SUMMARY REPORT  
FOR PACIFIC AIR PRODUCTS COMPANY  
SOLIDHD MOUNTING PLATES  
GRAND GULF NUCLEAR POWER STATION  
UNITS 1 & 2

SOLENOID MOUNTING PLATES

GRAND GULF NUCLEAR POWER STATION-UNITS #1 AND #2

Revision 0  
March 10, 1982

FCN  
GRAN No. M-1137

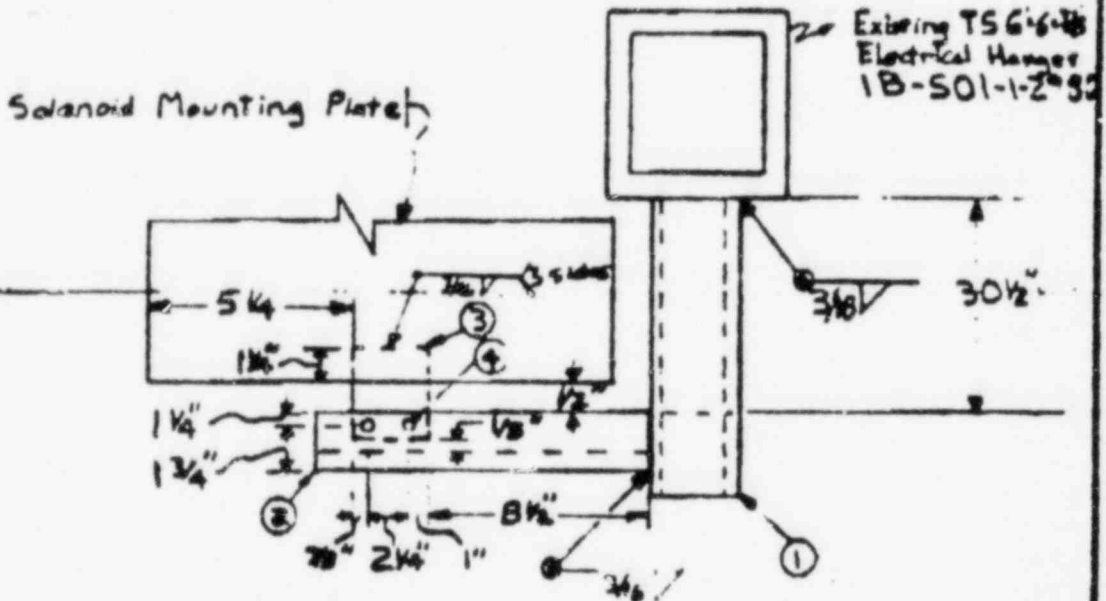
Change Request/Sketch (if necessary)  
Add support to Hiten Solenoid mounting plate on actuator Q12776001A.

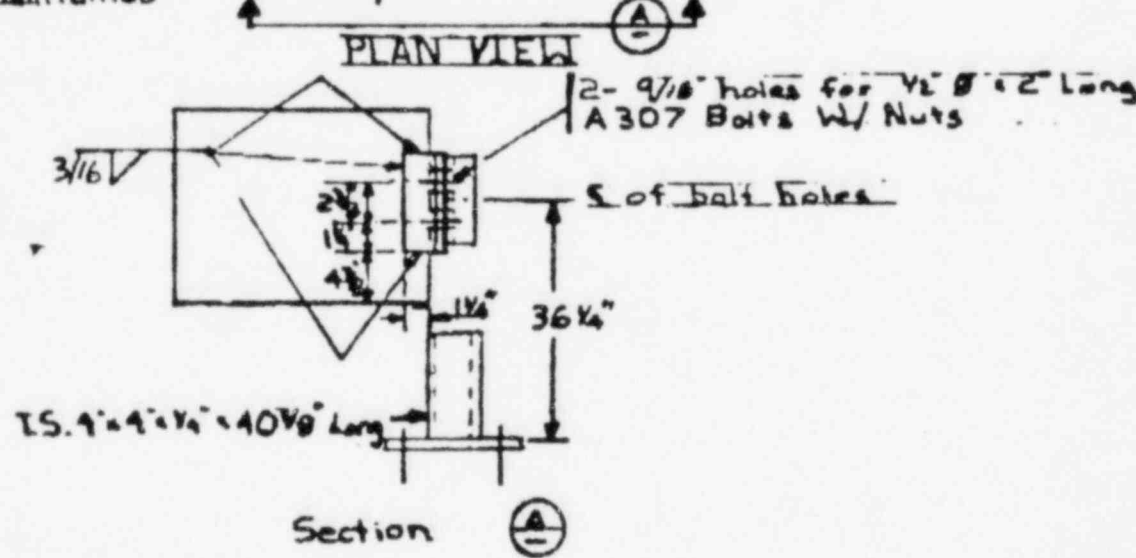
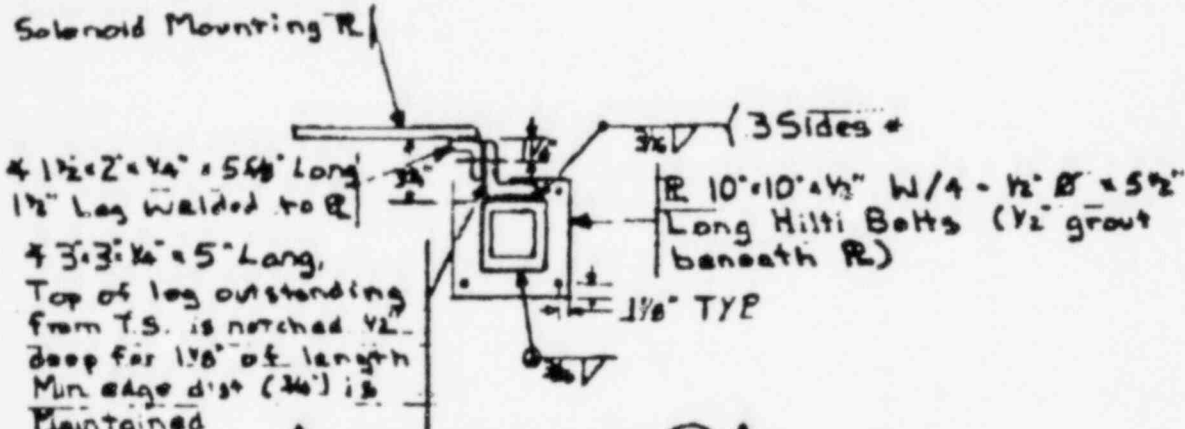
Add support to stinger external mounting plate on  
actuator Q12776001B,  
CHANGE REQUEST/SKETCH (IF NECESSARY)

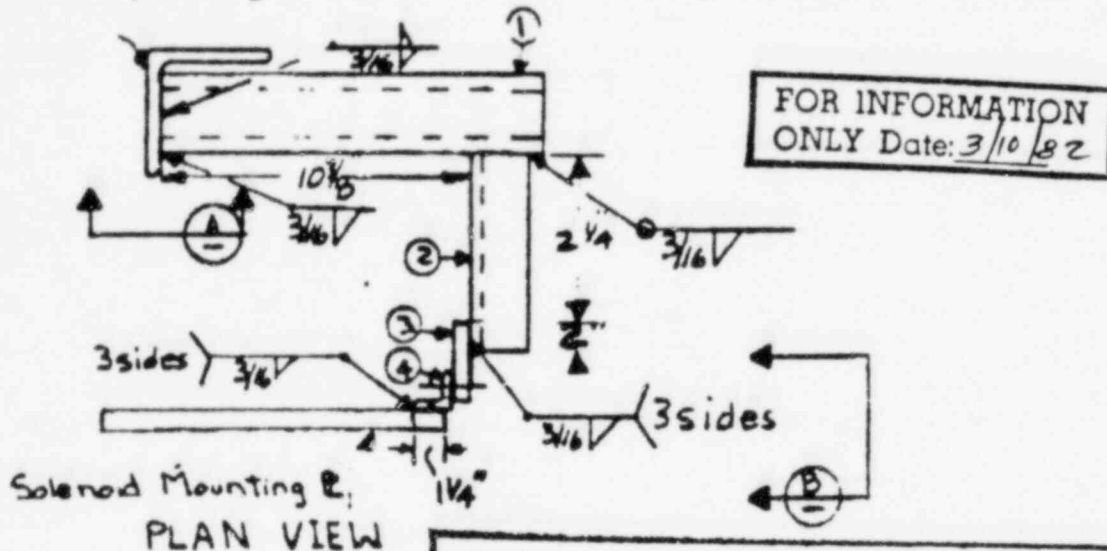
Add supports to stiffen electrical mount plate on  
actuators Q22775001Q.  
CHANGE REQUEST/SKETCH (IF NECESSARY)

ECN -  
GRAN No. M-1150

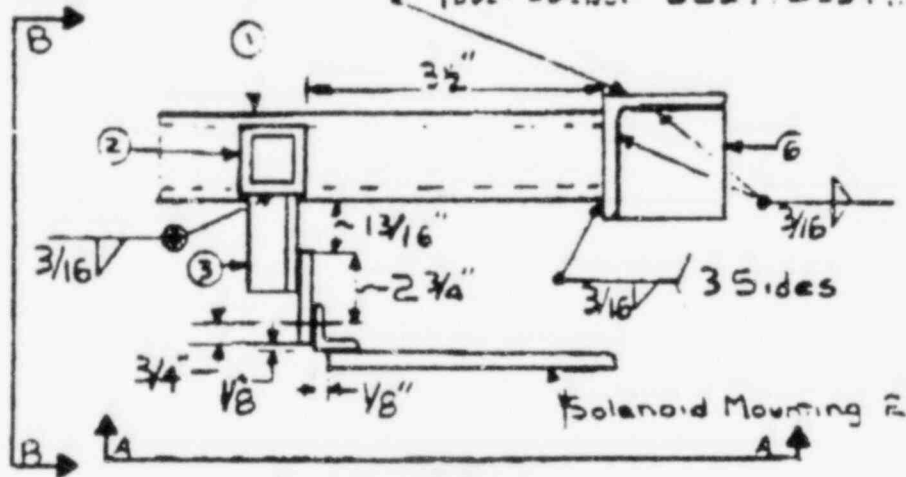
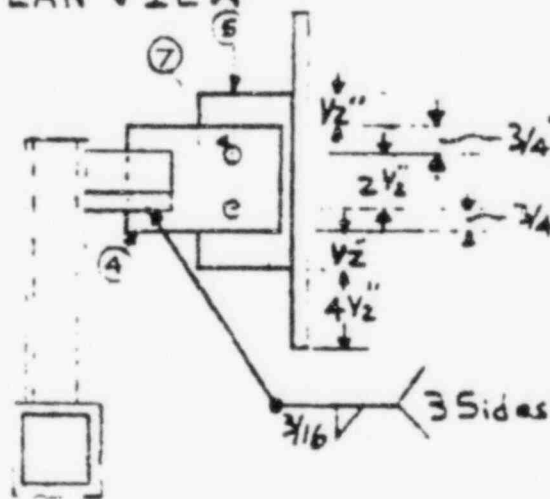
Add support to existing welded manway plate on  
actuator Q2E77G007A.

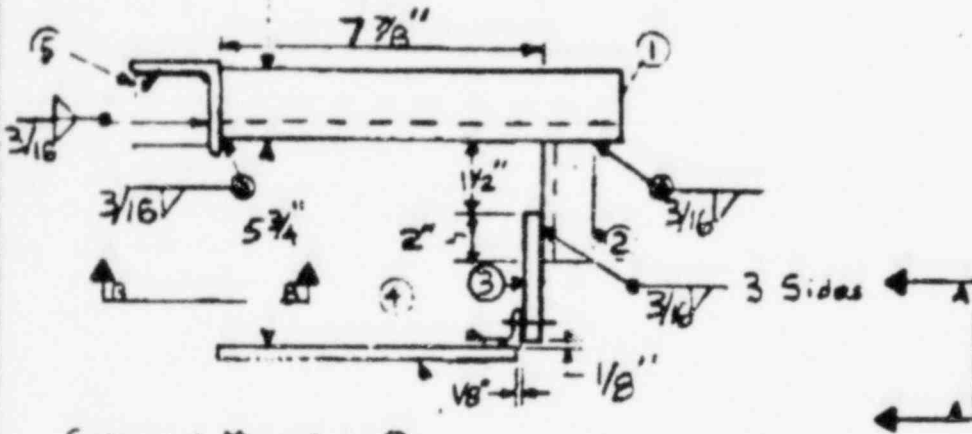
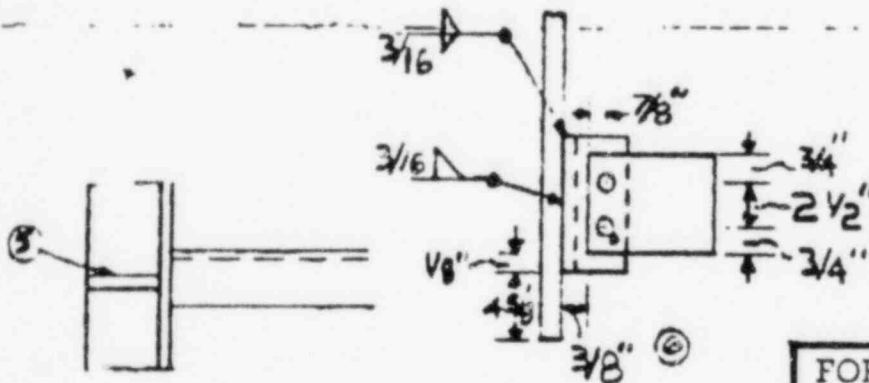
Add support to existing solenoid mounting plate on actuator Q22776035A.  
CHANGE REQUEST/SKETCH (IF NECESSARY)

Existing  $4 \times 3 \frac{1}{2} \times 3 \frac{1}{2} \times \frac{1}{2}$  : HVAC  
Duct Suppl - G2277G004 H12

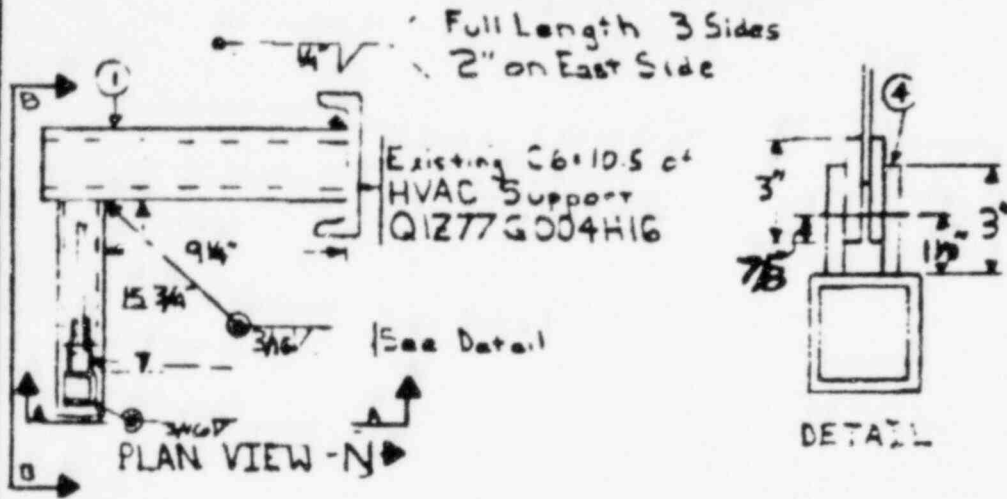
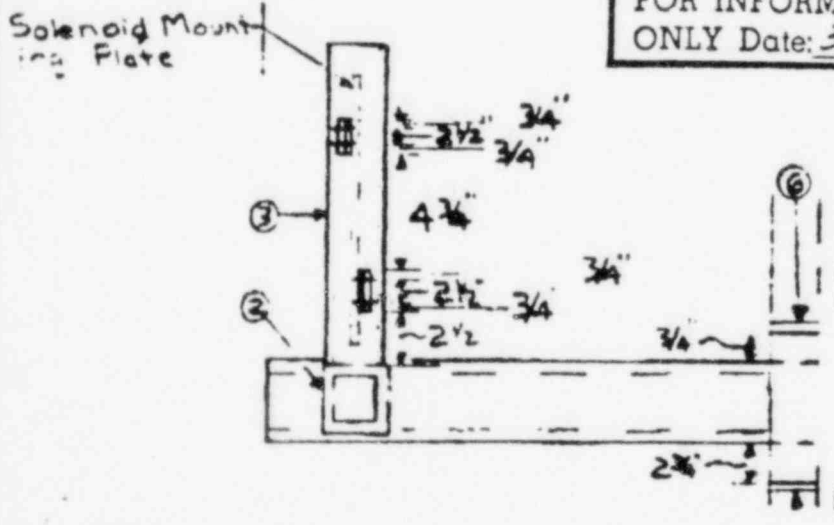
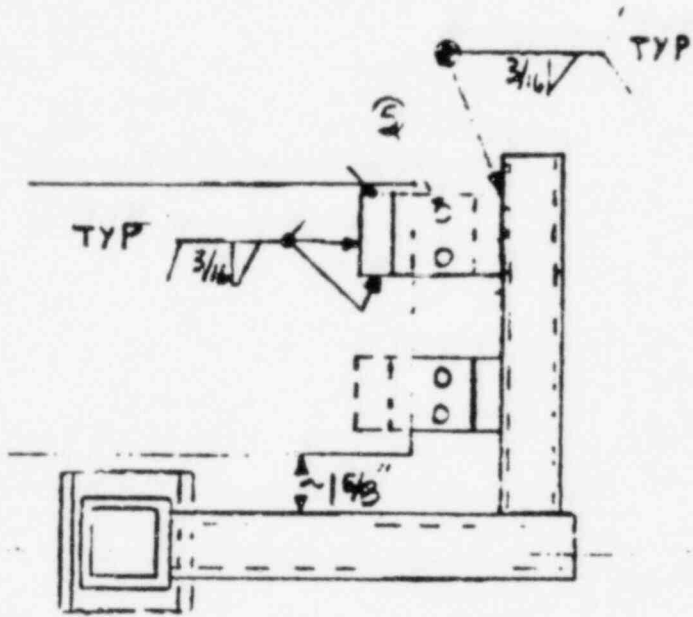
Add support to stiffen solenoid mounting plate on actuator Q1277603A.

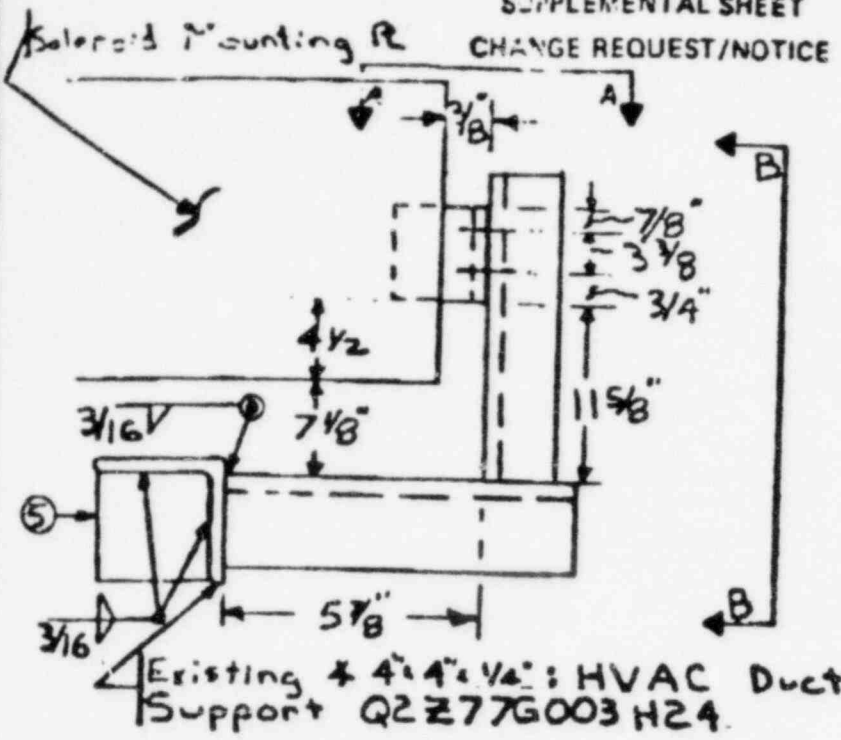
Add support to existing solenoid mounting plate on actuator Q22776003A.

FCN-  
CRAN No. M-1142

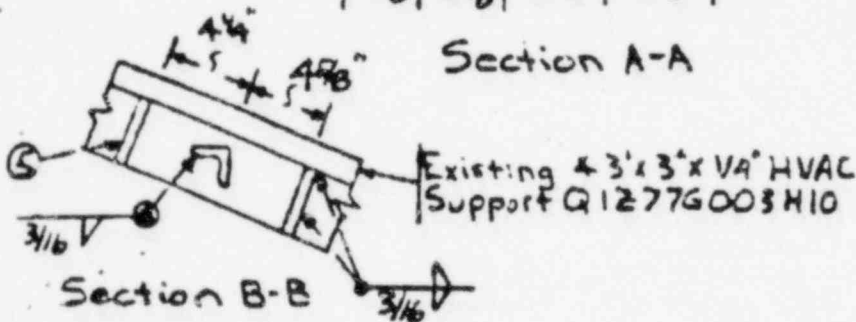
Add support to clutter cleaned mounting plate on actuator Q1E77G030.

FCN-  
DRAWING NO. M-1144

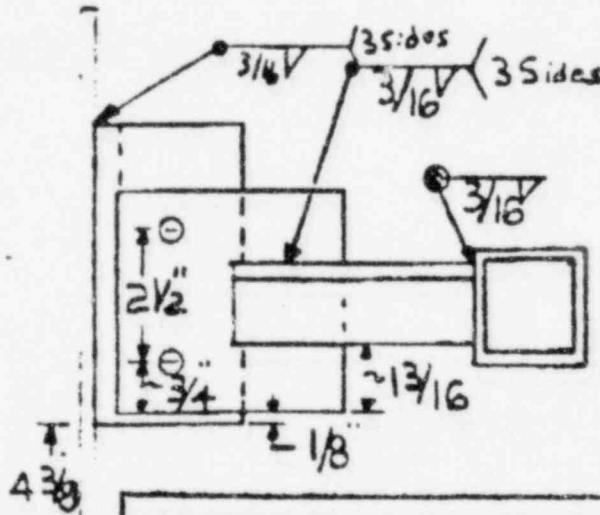
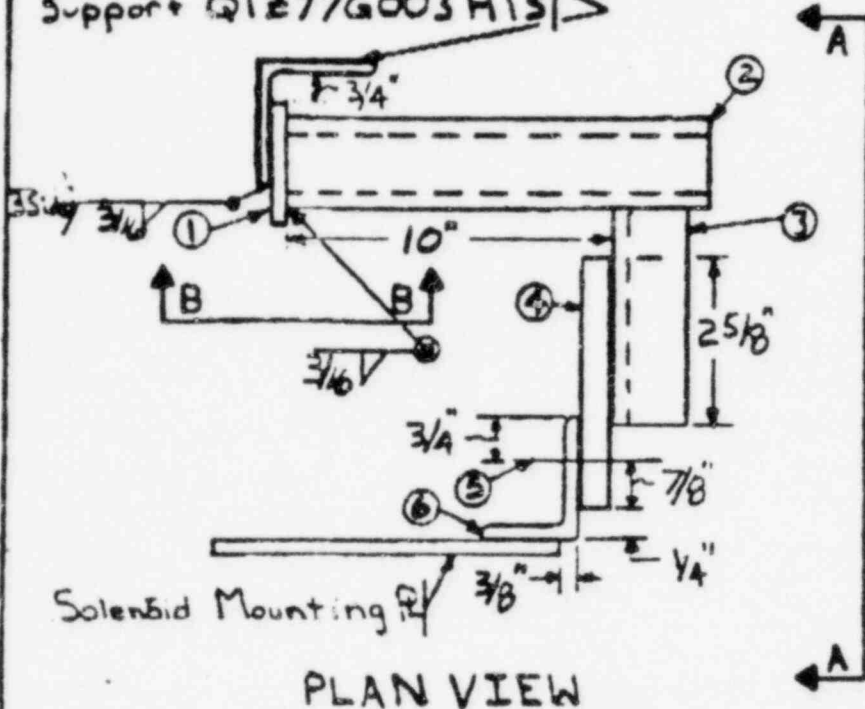
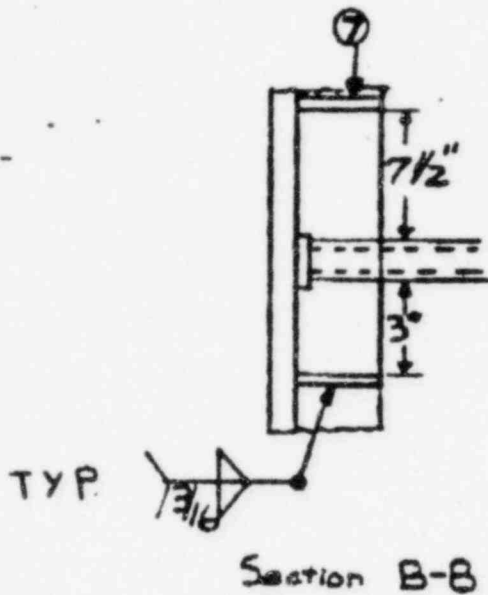
Add support to stiffen solenoid mounting plate on actuator Q1277603B.

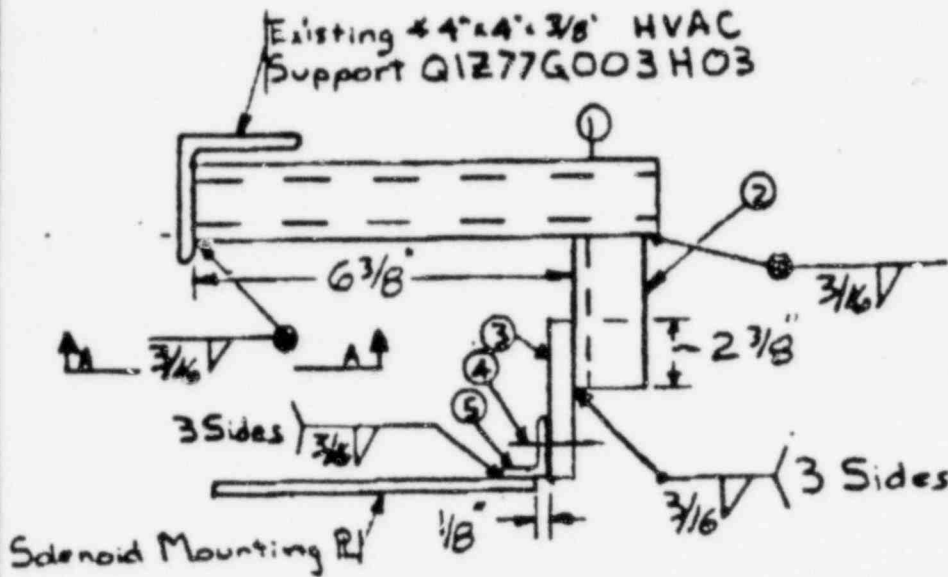
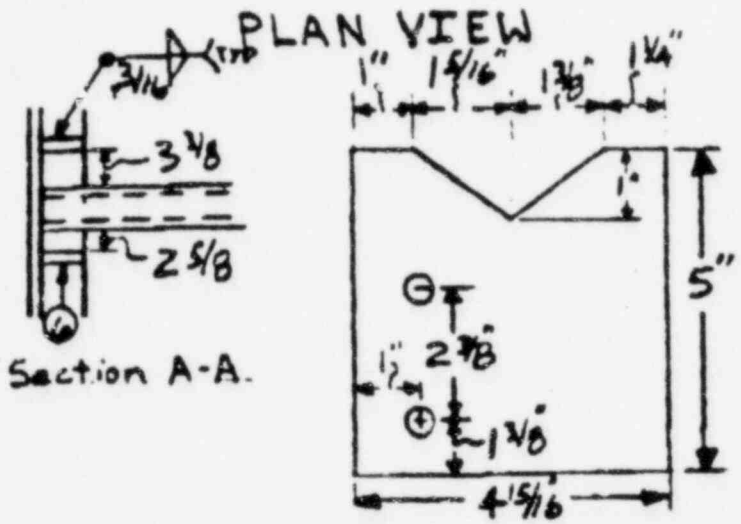
Add support to slotted solenoid mounting plate on actuator Q12776002A.

4 2" x 1/4" x 1/4" Bolted to back of plate as shown in Plan View w/ 2" long nutches to match plate. Bottom of R (item 3) & 2" x 1/4" x 1/4" (item 5) is 1/8" above bottom of Solenoid R.

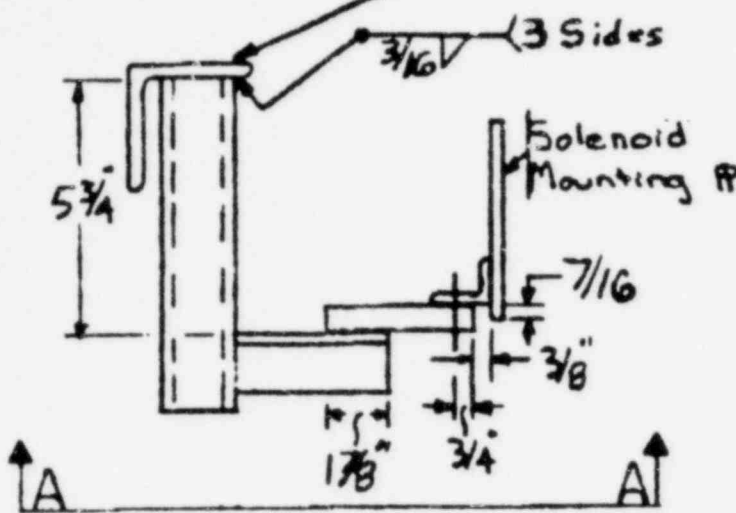
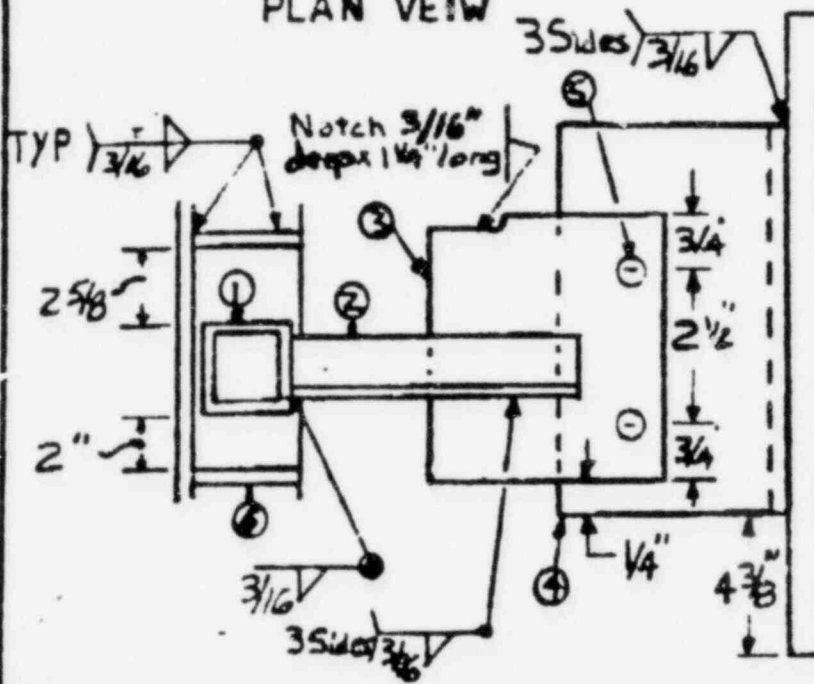
Add support to stiffen reload mounting plate on actuator Q1277602B.

SUPPLEMENTAL SHEET  
 CHANGE REQUEST/NOTICE  
 Existing 4'3" x 3' x 3/8" HVAC Support Q12776004H10
